UNITED STATES PATENT AND TRADEMARK OFFICE

09/892,790

Office Action Summary	Application No.	Applicant(s)	
	09/892,790	PARK ET AL.	
	Examiner	Art Unit	
	William J. Klimowicz	2627

DETAILED ACTION

FIG.4

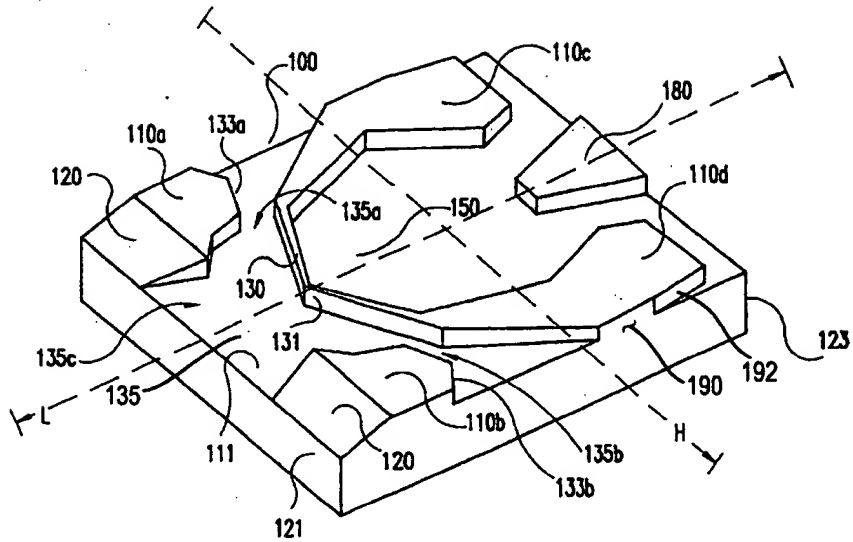
The amended drawings filed on August 22, 2007 (received by the Patent Office on August 24, 2007) have been approved.

The drawings, in the opinion of the Examiner, comply with the written description requirement of 35 USC 112 1st paragraph. The drawings changes filed August 22, 2007, contain subject matter which was described in the original disclosure in such a way as to reasonably convey to one skilled in the relevant art that the inventor(s), at the time the application was filed, had possession of the drawing changes.

The U-shaped air-bearing platform circumscribes a majority of negative pressure cavity 150 that is formed on principal surface 111. At least one of the rear ABS platforms 110c, 110d includes a sidewall 190 that is contiguous with *side edge 192 of slider body 100* extending between lead edge 121 and rear 123 . . . [Emphasis added - see Applicant’s amended FIG. 4, also filed on August 22, 2007.]
